DATE: April 19, 2022

CASE: TA-03-22 Text Amendment (Articles 2 and 3 of the TSM)

DATE: April 6, 2022

CASE: Executive Summary for Technical Standards Manual (TSM)
Articles 2 and 3

Figure 7-1: Two Streets Intersecting the Same Street.

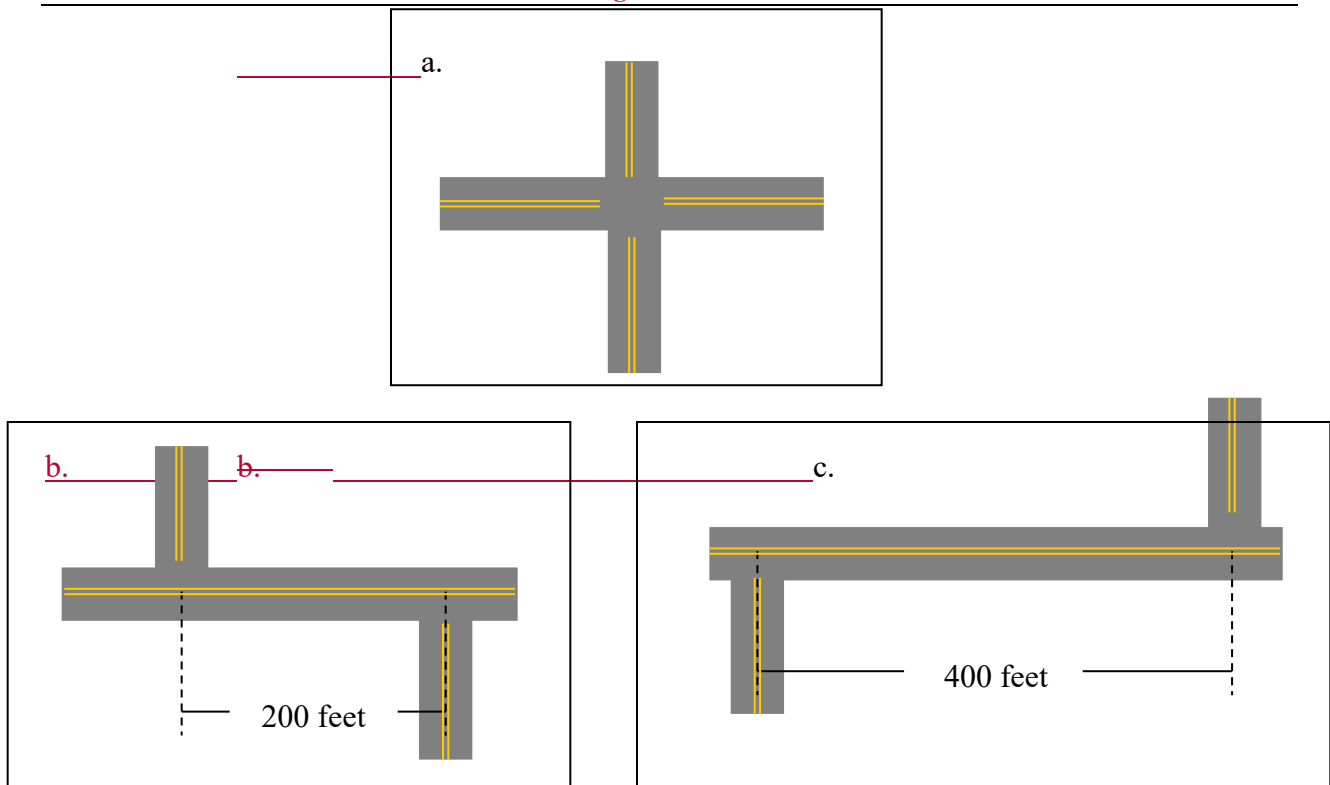
7.3.7.4. Distances between Intersections. -Proposed streets that intersect opposite sides of the same street (either existing or proposed) should be designed to intersect directly opposite one another as shown in Figure 7-1a.

1. A minimum length of 200 feet between street-centerlines must separate proposed streets that cannot be aligned to create a shared intersection as shown in Figure 7-1b.
2. A minimum length of 400 feet between centerlines must separate streets with opposing left-hand turns as shown in Figure 7-1c.

- ~~1. A minimum length of 200 feet between street centerlines must separate proposed streets that cannot be aligned to create a shared intersection as shown in Figure 7-1b.~~
- ~~2.1. A minimum length of 400 feet between centerlines must separate streets with opposing left hand turns as shown in Figure 7-1c.~~

Figure 7-2: Type 1 & 2 Sight Triangle Sample Illustration

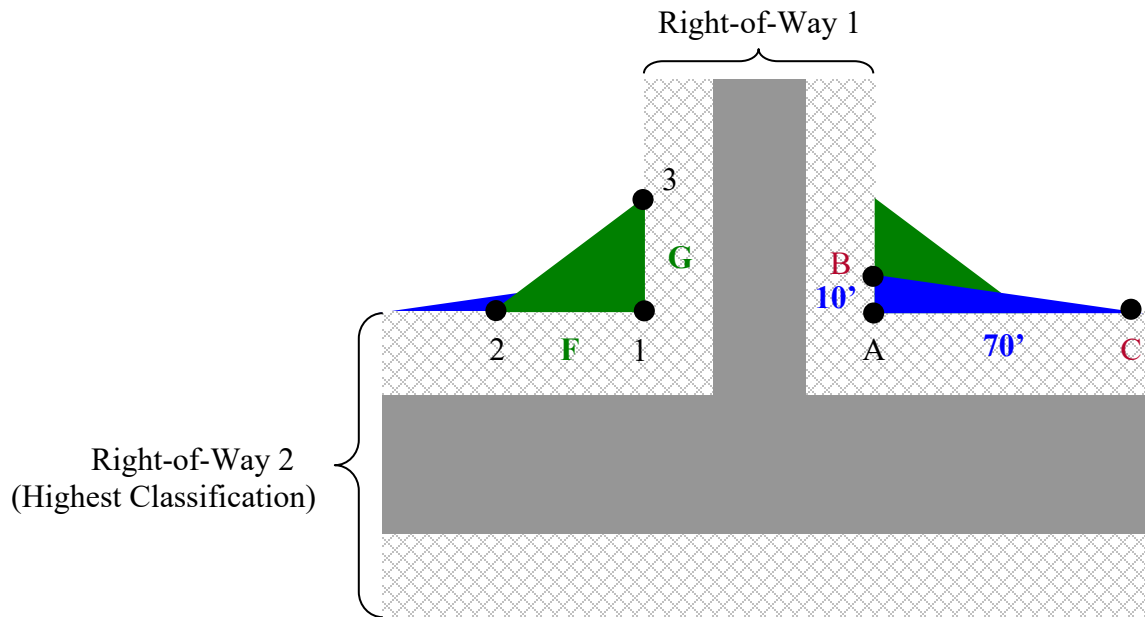
2. Type 1 Sight triangles are measured from the following three points as shown on Figure 7-2:

2b. Size and Measurement - A sample illustration is provided in Figure 7-2.

1. Type 2 Sight triangles are measured from the following three points as shown on Figure 7-2:

c. *Point C.* The point along right-of-way two (2) a distance of 70 feet from Point A.

~~b. *Size and Measurement.* A sample illustration is provided in Figure 7-2.~~

Figure 7-3: Type 3 Sight Triangle Sample Illustration

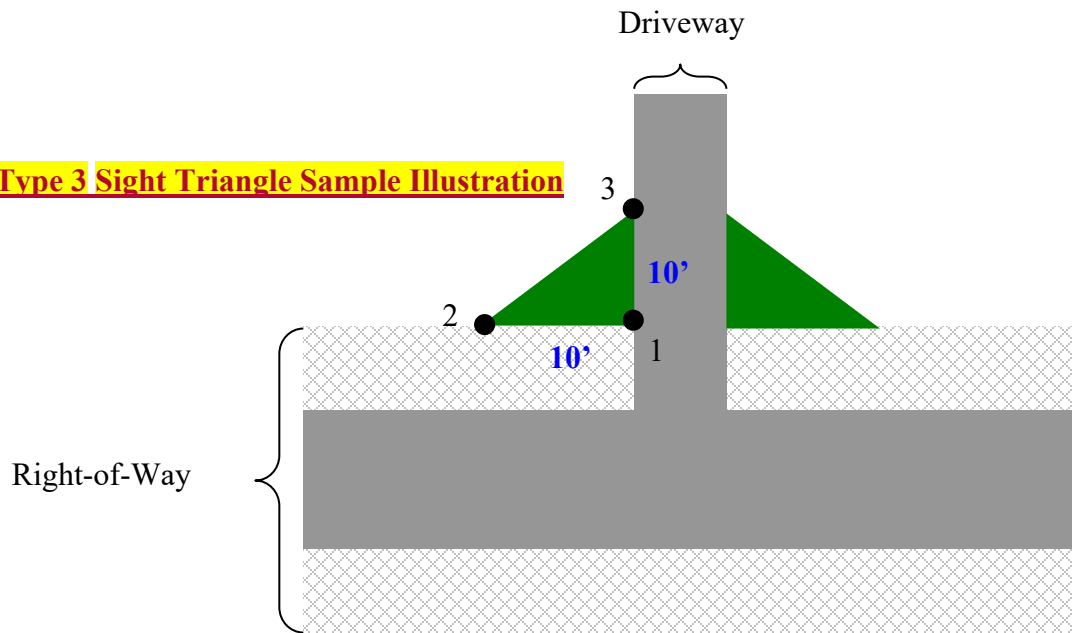
b. Size and Measurement - A sample illustration is provided in Figure 7-3.

3c. Point 3. The point along the edge of the driveway pavement a distance of ten (10) feet from Point 1

Figure 2.4-1: Existing Development Expansion Example

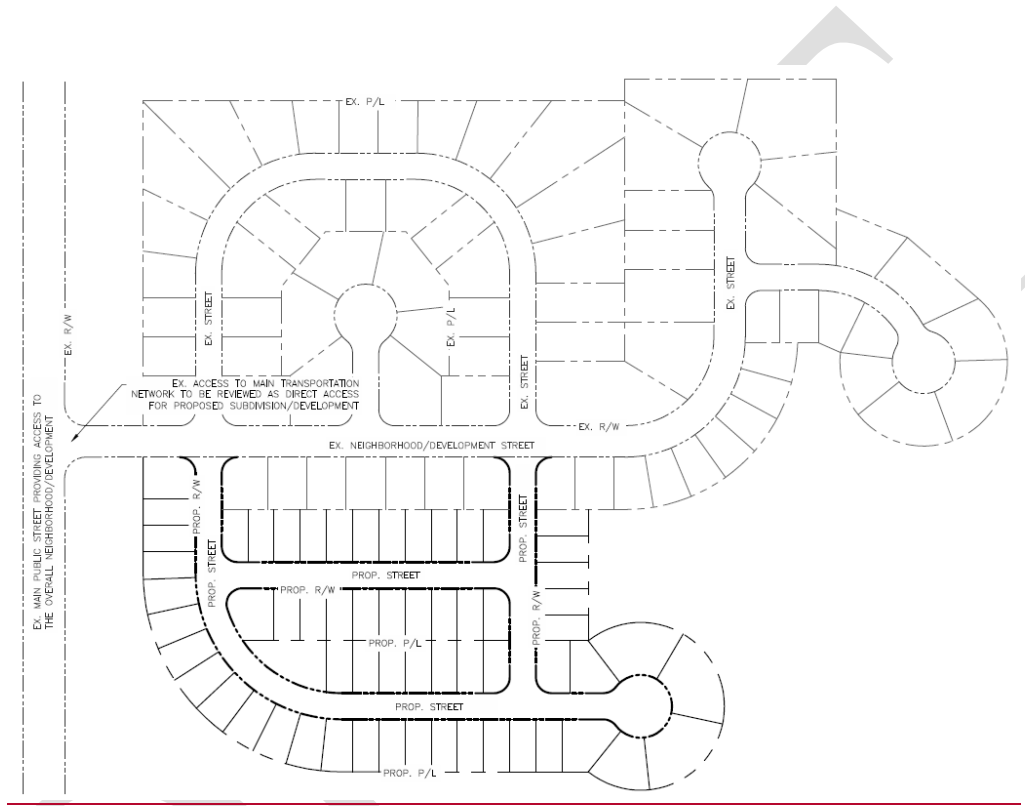
considered an expansion of the existing neighborhood/development and the existing entrances may be considered direct access entrances serving the proposed development and may be subject to current standards as they would apply to the proposed development. See figure 2.4-1 for an example.
